SUBJECT:	No: TSB-03-26-002 DATE: August, 2003 MODEL: 2001-03 Montero		
NOISE FROM F			
WHEEL HUB B			
CIRCULATE TO:	[] GENERAL MANAGER	(X) PARTS MANAGER	[X] TECHNICIAN
[X] SERVICE ADVISOR	[X] SERVICE MANAGER	[X] WARRANTY PROCESSOR	[] SALES MANAGER

This bulletin contains information about improvements to the front wheel hub bearing for certain 2001-03 Montero vehicles.

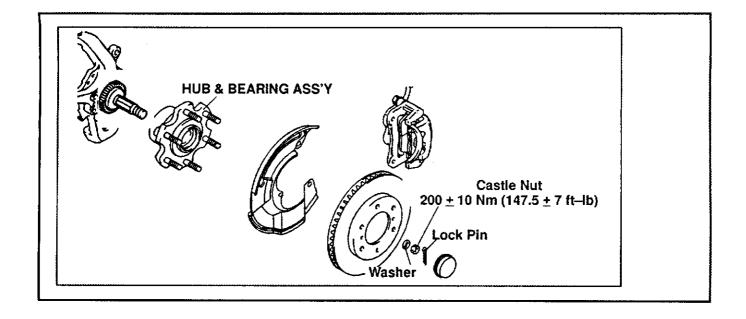
This bearing noise may be caused by excessive bearing wear because of water penetration into the bearing.

If you identify this condition, replace the hub and bearing assembly along with the castle nut with parts supplied in a new front wheel hub/bearing assembly kit.

When installing the new hub assembly, make sure the castle nut is tightened to the new torque value (200 \pm 10 Nm [147.5 \pm 7 ft-lb]). The new-style castle nut is modified with a friction coefficient stabilizer and has a green color on its surface.

The modified castle nut, washer, and lock pin cannot be re-used once the nut has been tightened.
